UNITED STATES PATENT AND TRADEMARK OFFICE

APPLICATION NO.	FILING DATE	FIRST NAMED INVENTOR	ATTORNEY DOCKET NO.	CONFIRMATION NO.
09/532,775	03/22/2000	Takashi Kano	000352	8757

Office Action Summary

DETAILED ACTION

F I G. 1

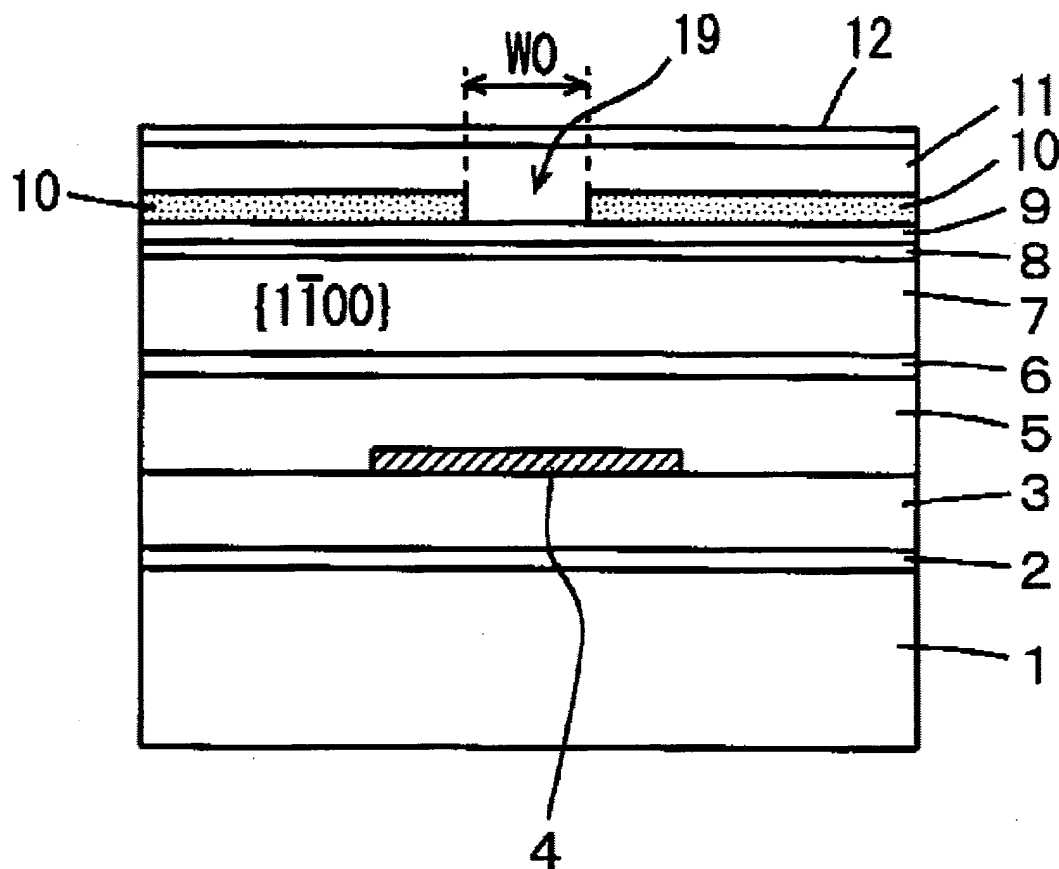
With respect to claim 1, Hayashi et al discloses a method of forming nitride based semiconductor layer comprises a sapphire substrate (1), an AlGa_N buffer layer (2), undoped Ga_N layer (3), SiO₂ film (4), n-Ga_N layer (5), n-InAlGa_N crack preventing (6), n-AlGa_N gladding (7), multi quantum well active layer (8), p-AlGa_N cladding layer (9), current blocking layer (10), p-AlGa_N cladding layer (11), p-Ga_N contact layer (12), current injection region (19), and striped region having a width WO, note cols. 3-12, see fig 1.

With respect to claim 3, Hayashi et al shows the nitride based semiconductor layer includes a first cladding (7n), an active layer (8), and a second conductivity type first cladding layer (11), see fig. 1.

With respect to claims 11 and 15-16, Hayashi et al discussed about the active layer includes at least one quantum well layer containing indium, gallium and nitrogen (8), note cols. 3-12, see fig 1-6.
